## PRODUCT/PROCESS CHANGE NOTICE (PCN)

<b>PCN #:</b> TB1303-01 <b>DATE:</b> April 1, 2013 <b>Product Affected:</b> TQFP-32, TQFP-48 shipped in <b>Tape &amp; Reel</b> (Refer to Attachment II for affected part#) <b>Date Effective:</b> <b>July 1, 2013</b>	<b>MEANS OF DISTINGUISHING CHANGED DEVICES:</b> <input type="checkbox"/> Product Mark <input type="checkbox"/> Back Mark <input type="checkbox"/> Date Code      Shipment starting from July 1, 2013. <input checked="" type="checkbox"/> Other
---	---

### ATTACHMENT I - PCN #: TB1303-01

**Detail of Change:** This notification is to advise our customers that IDT has qualified a new revision of a carrier tape for packages TQFP-32 and TQFP-48.

**Figure1: Illustration on Existing Carrier Tape and New Carrier Tape**

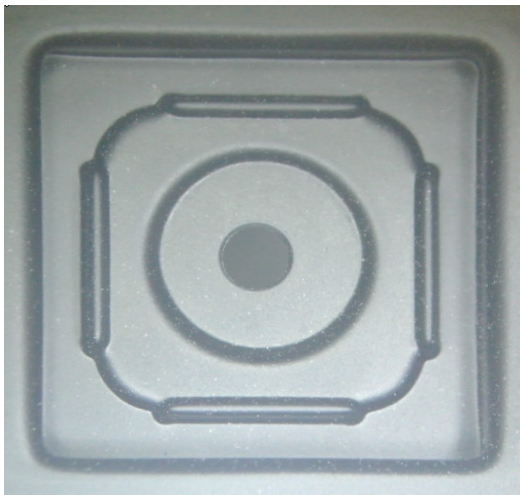
The new carrier tape has changes in pocket dimensions and design that enhances pick and place function during board mount process. The new carrier tape is designed with increased pocket depth from 1.3mm to 1.55mm, which will avoid unit protruded above the top surface of the carrier tape.

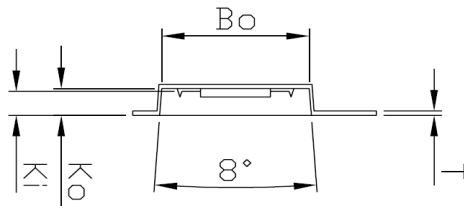
Refer to Table 2 for the comparison of the existing and new carrier tape.

TOLERANCES UNLESS OTHERWISE SPECIFIED		ANGLE ±.5°	
DECIMAL	X ± .25		
.XX ± .13			
.XXX ± .13			
APPROVALS	DATE	WWW.IDT.COM	
DRAWN		TITLE: ES/ESG 48 & PR/PRG 32/48 CARRIER TAPE (PCT)	
STOCK NO. P8-159-P32		DRAWING NO. MSC-3378	
DO NOT SCALE DRAWING		REV N/A	
		SCALE N/A	
		REV 03	
		SHEET 1 OF 2

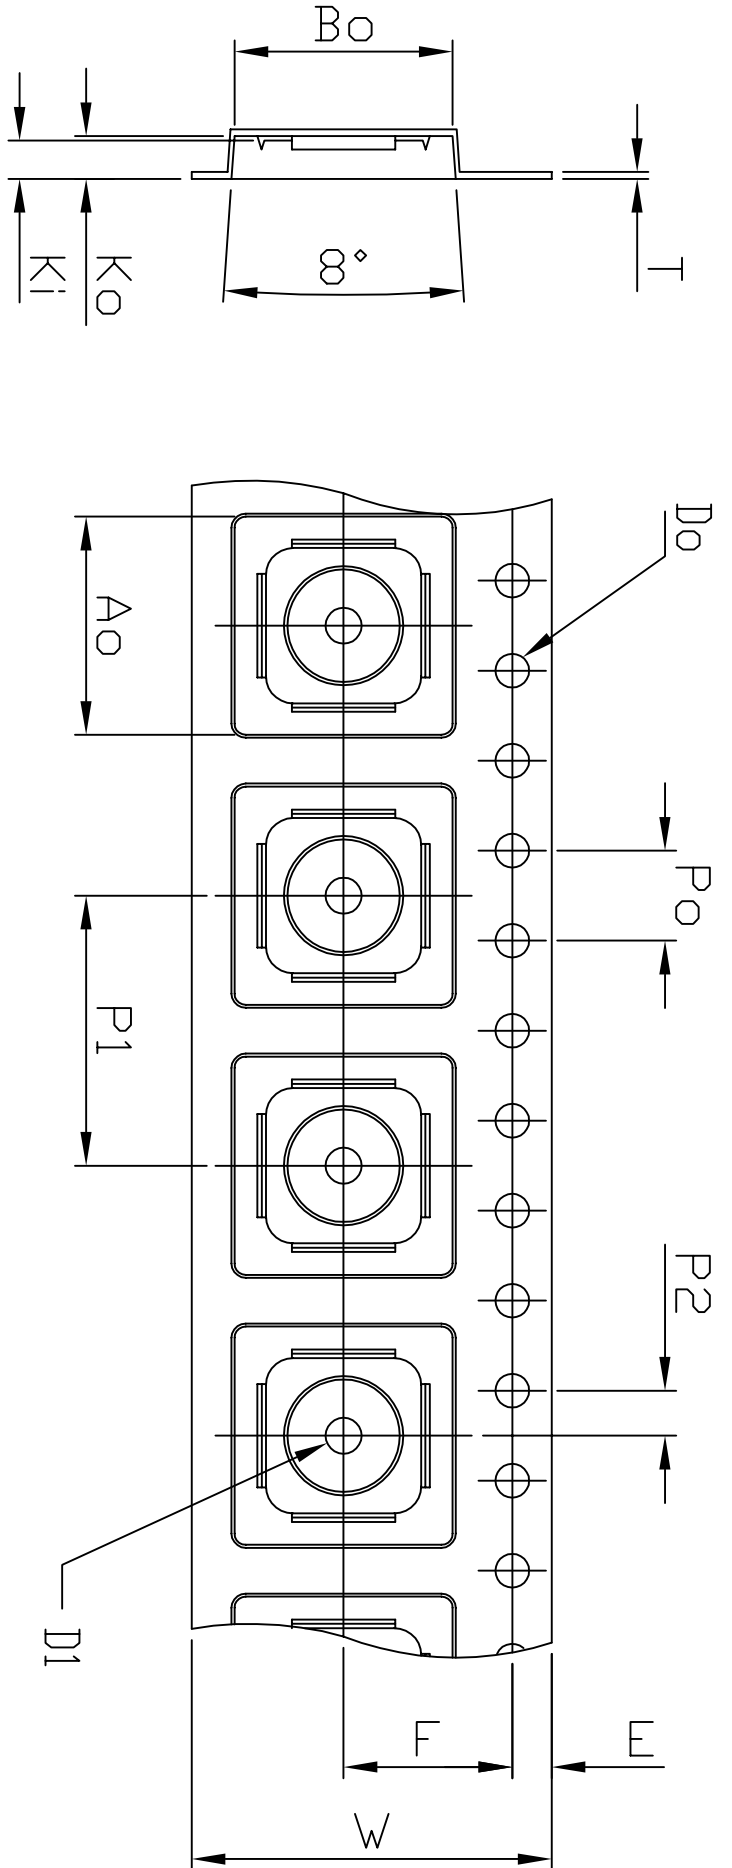
Description	Existing Carrier Tape (part#: P8-159-P32)	New Carrier Tape (part#: P8-422-000)
Pocket Width, Ao (mm)	9.8 ± 0.1	9.5 ± 0.1
Pocket Length, Bo (mm)	9.8 ± 0.1	9.5 ± 0.1
Pocket Depth, Ki (mm)	1.3 ± 0.1	1.55 ± 0.10
Pocket Pitch, P1 (mm)	12.0 ± 0.1	12.0 ± 0.1
Total Pocket Depth, Ko (mm)	1.8 ± 0.1	2.0 ± 0.1
Carrier Tape Width, W (mm)	16.0 ± 0.3	16.0 ± 0.3
Carrier Tape Thickness, T (mm)	0.30 ± 0.05	0.30 ± 0.05
